# PLAN COMMISSION

December 11, 2023 at 5:30 PM

- A. Review of Site and Architectural Plan for 1509 Washington Street, submitted by Adam Stein of Logic Design & Architecture, Inc.
- B. Review of additional materials submitted for Conditional Use Permit application for use of self-storage units on 15<sup>th</sup> Street, for parcel 053-000-076-015.03, submitted by Alliance Construction and Design and Eric Burrows (owner).
- C. Review of request to change the sign ordinance to permit signs placed onto sidewalks.

**Action:** Site and Architectural Review, 1509 Washington Street, 0.643 acres

Drawing Title  
**PROPOSED ELEVATIONS**

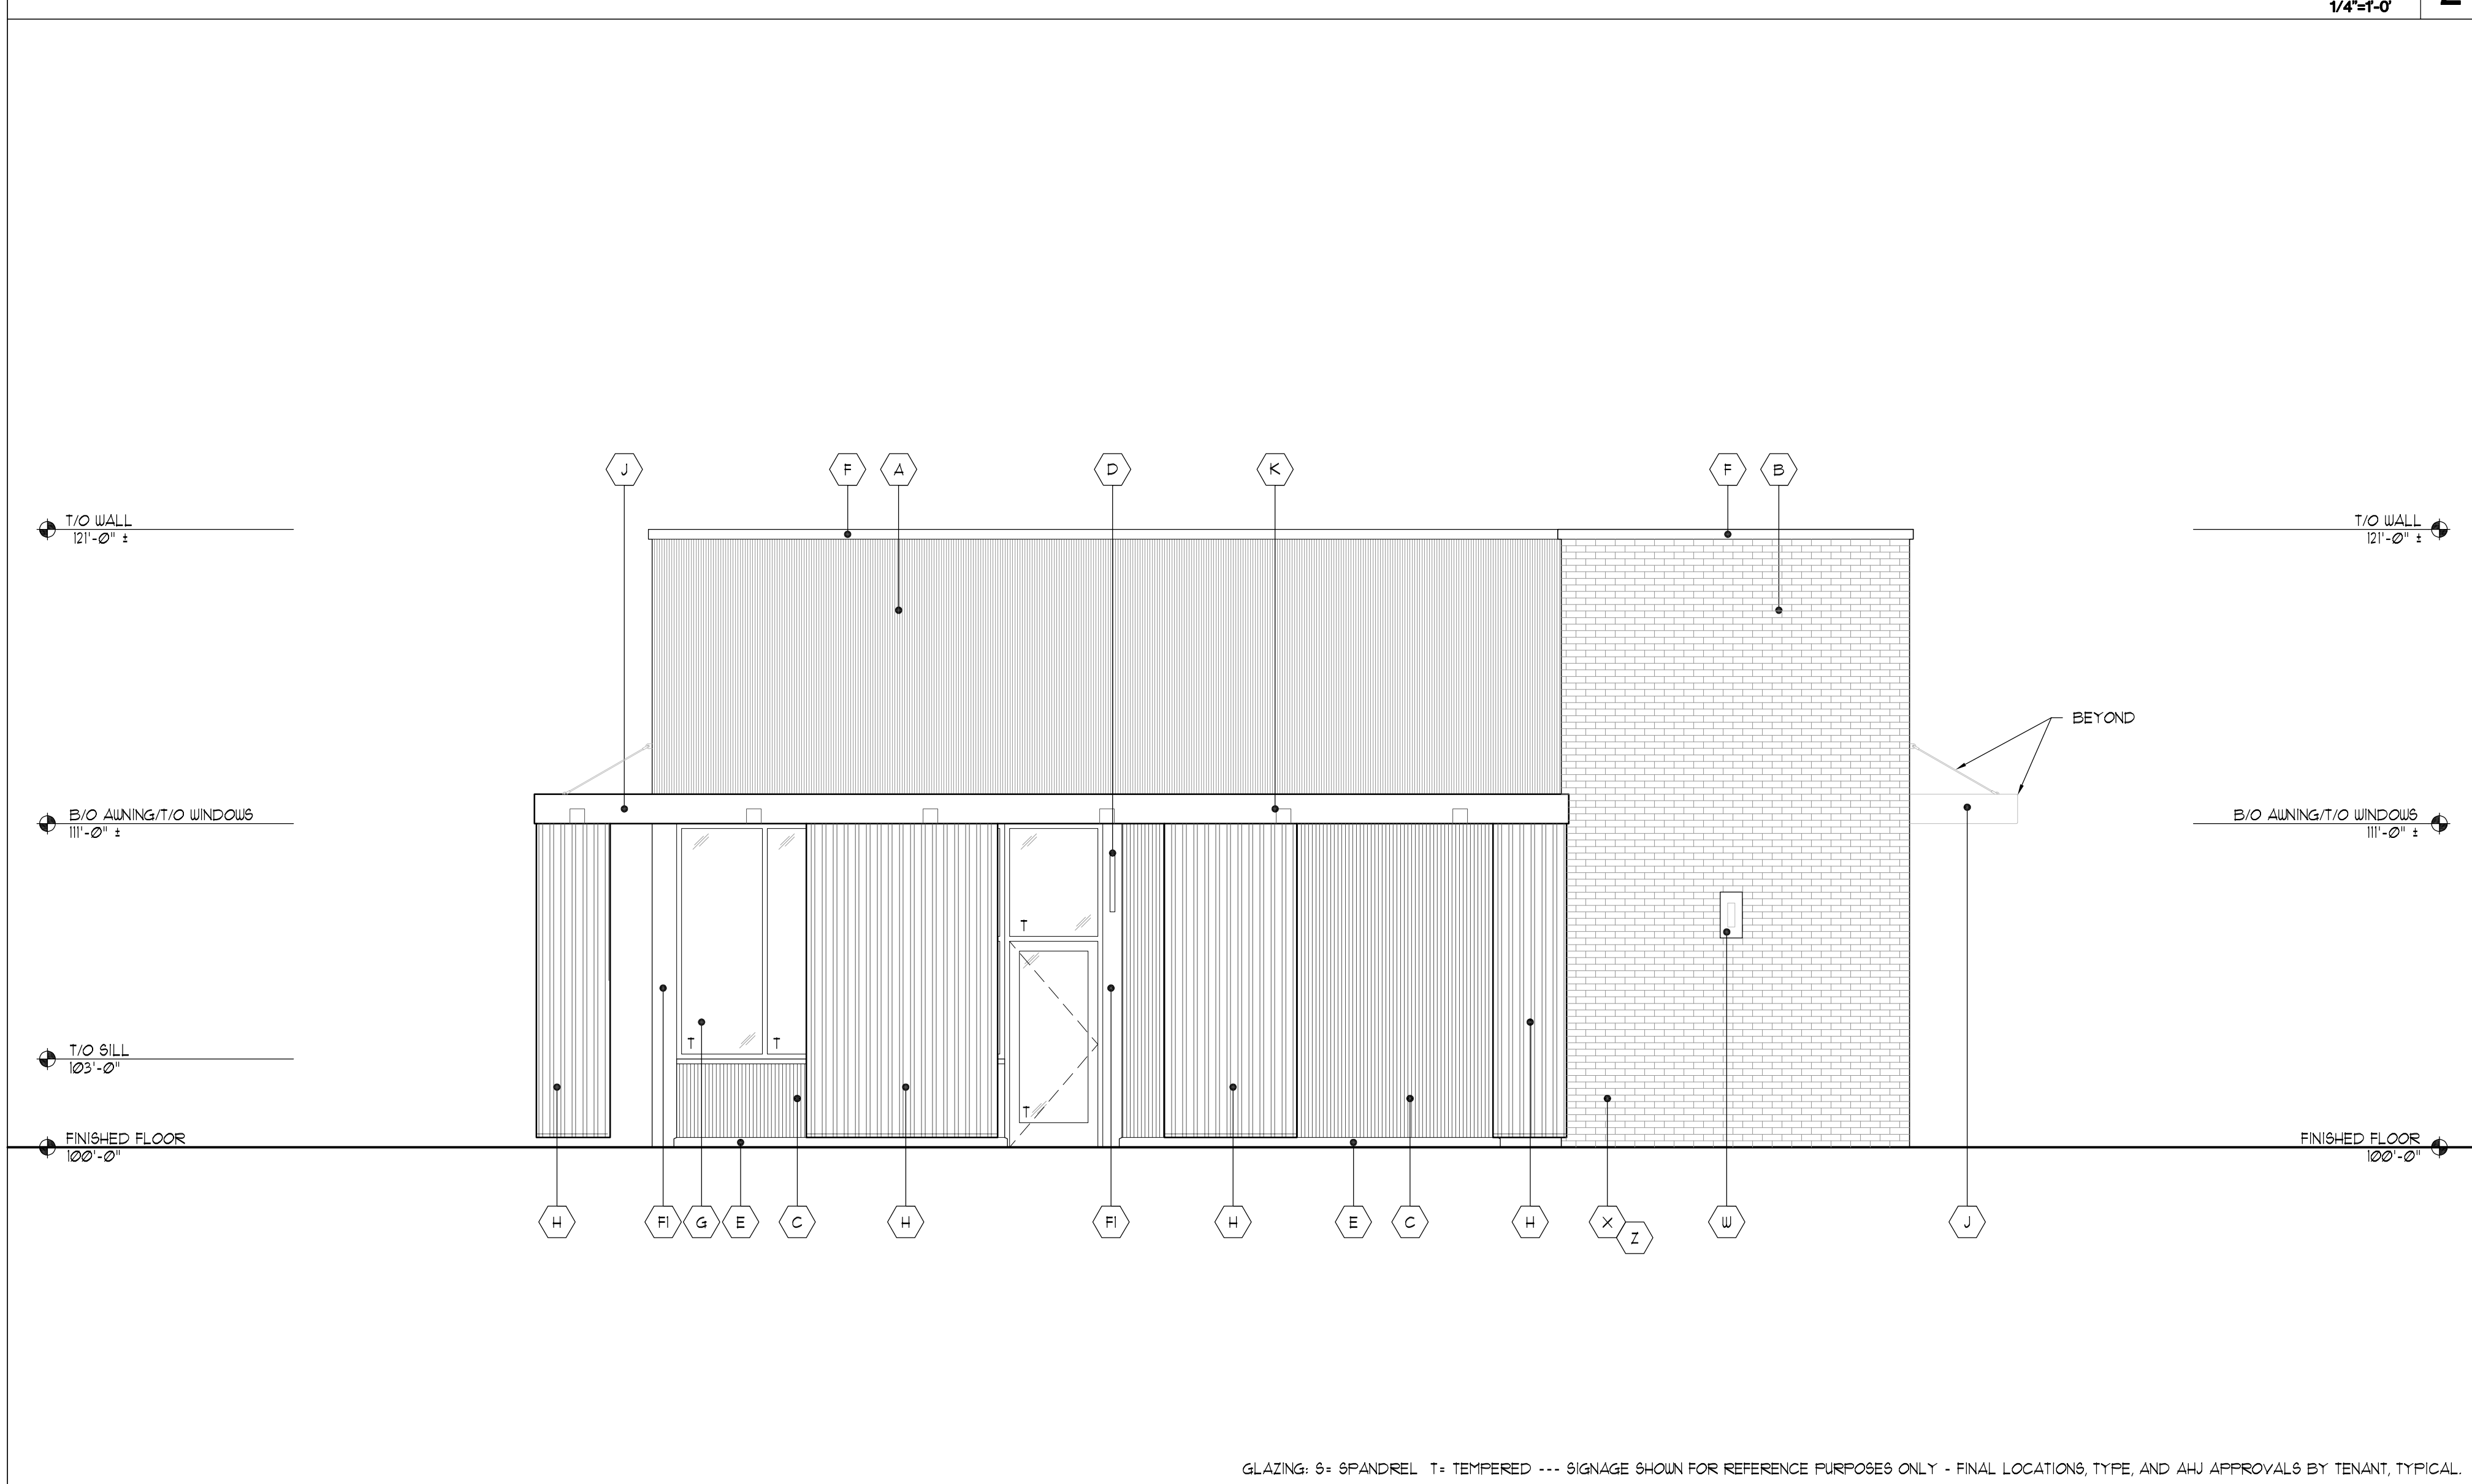
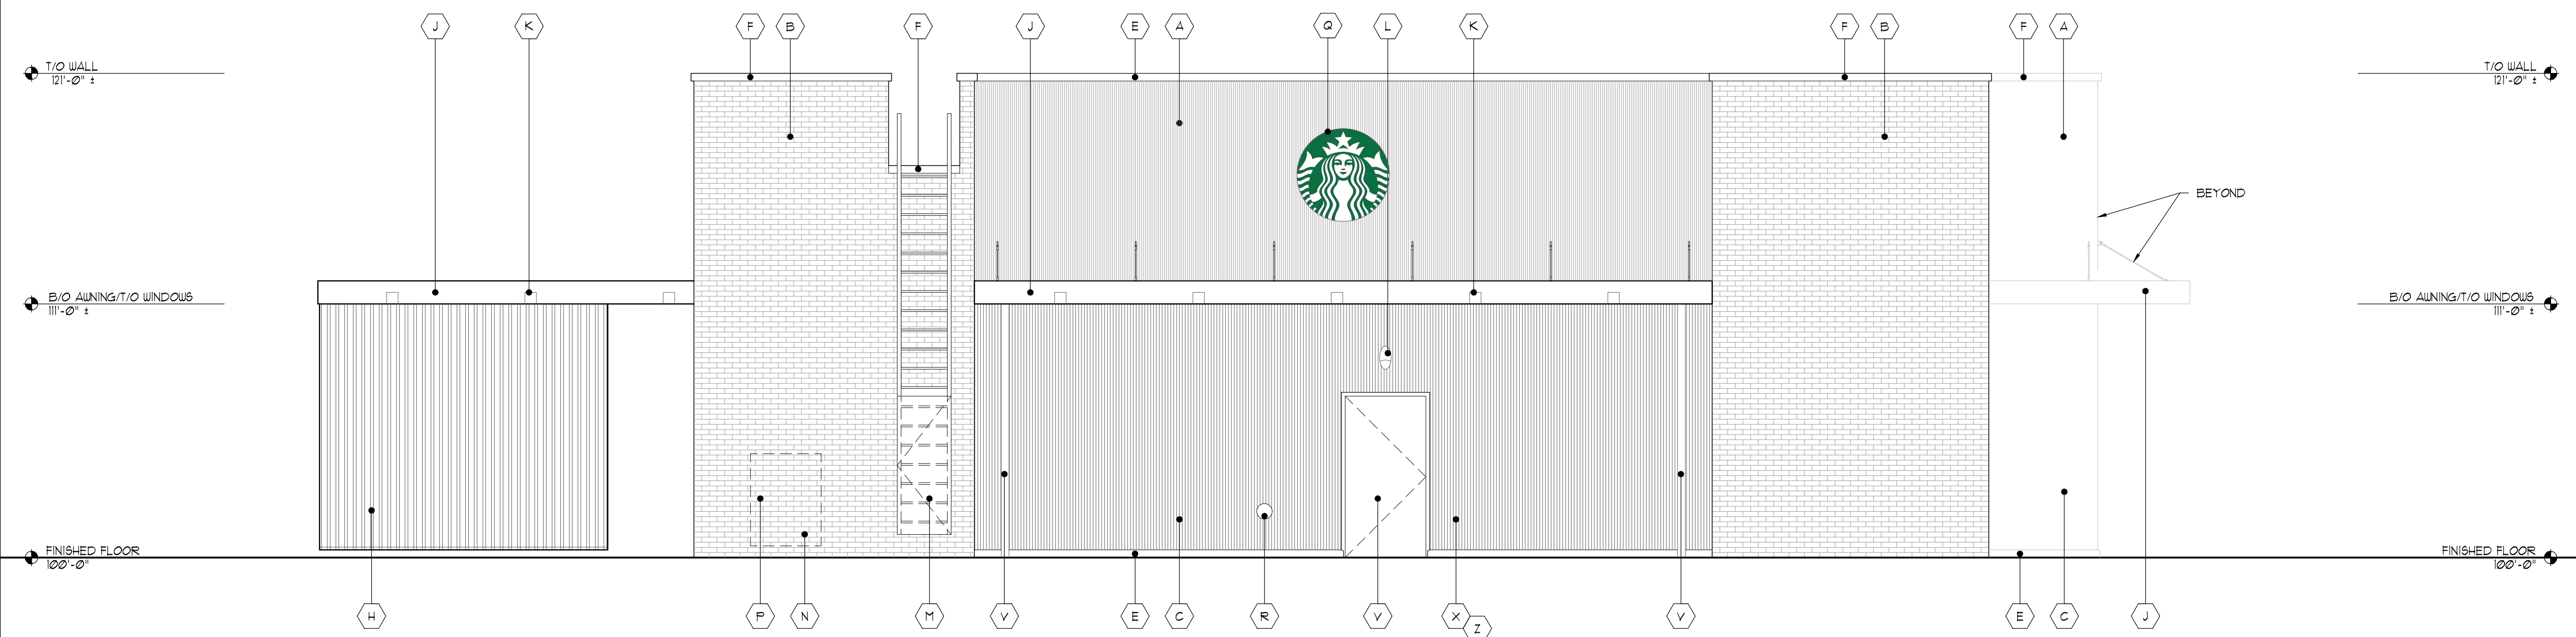
The elevations show a 580 square foot outdoor patio space. Is this space going to be heated? If so, there may be additional building code questions.

The elevations show a ladder. The ladder itself is a concern. As shown, there does not appear to be any restriction of access to it and to the roof. The need for the ladder as a fixture on the building is a concern for safety reasons.

SANITARY & WATERMAIN PLAN

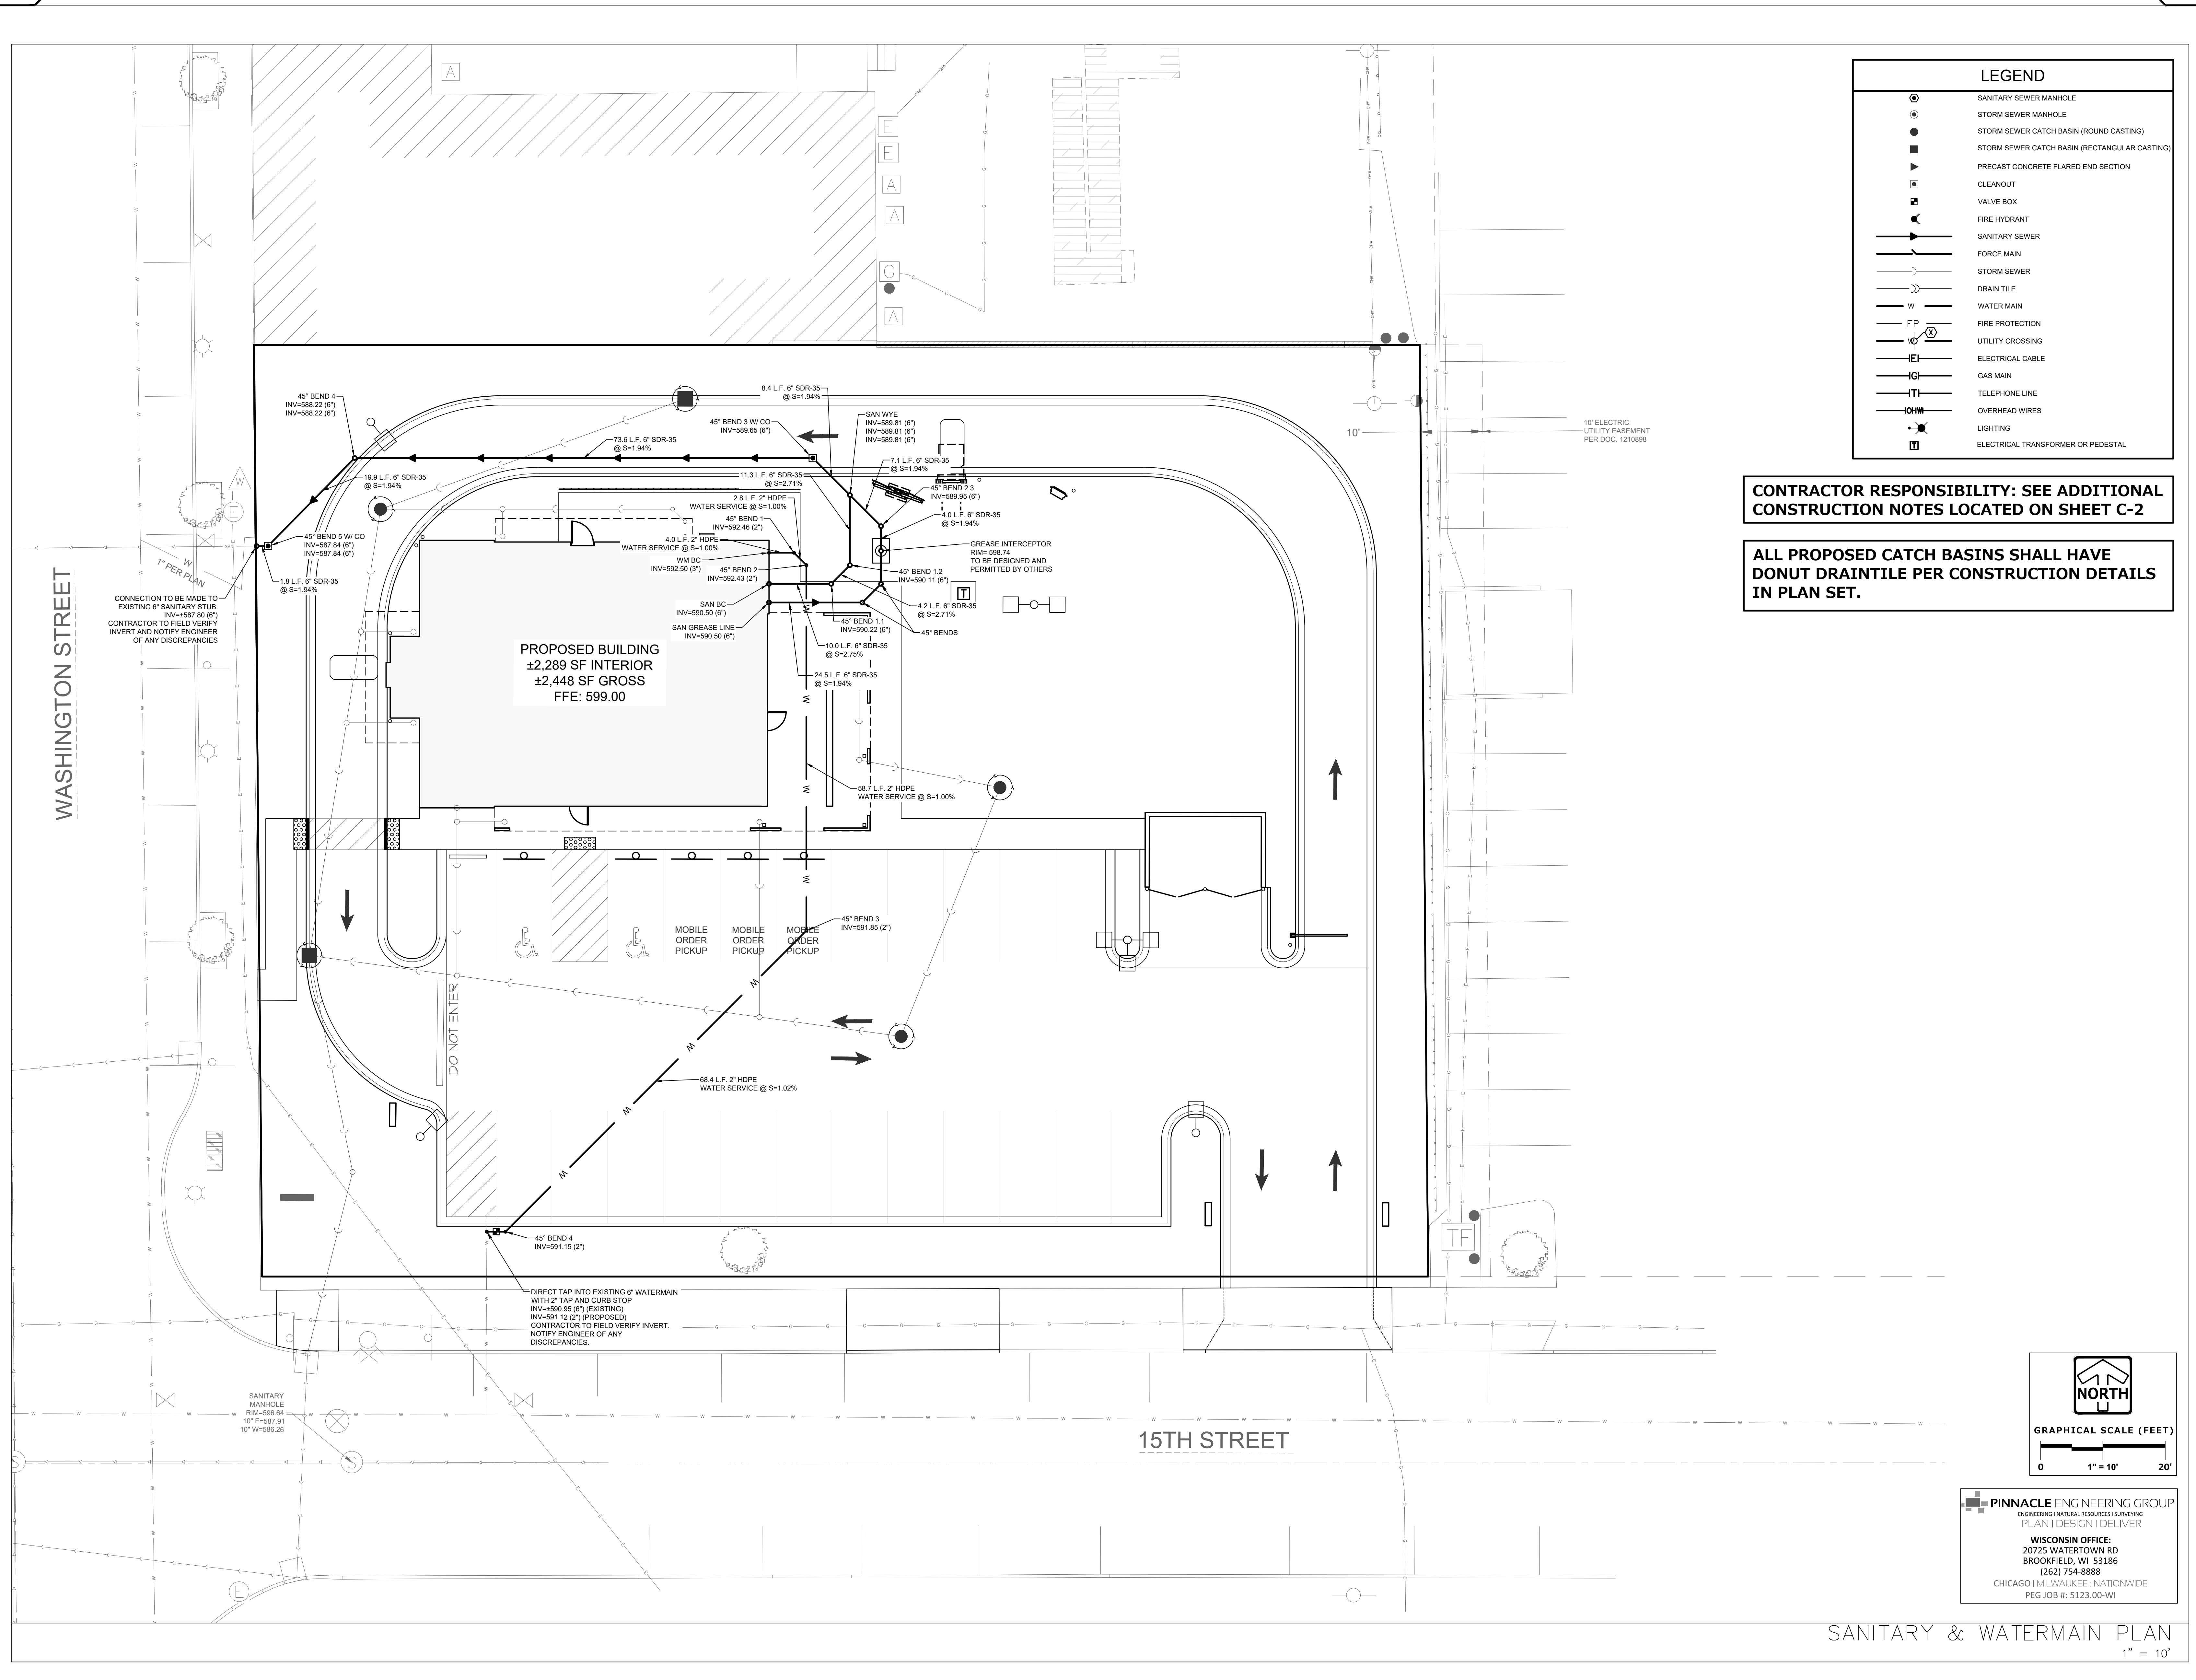
- Water proposed 2-inch service tapping onto the existing 6-inch service off of 15<sup>th</sup> Street;
- Sanitary sewer will be serviced as shown off the northwesterly portion of the proposed building; and
- Storm sewer plan shows connection to an existing catch basin. The connection is to be “cored and booted” in 15<sup>th</sup> Street.
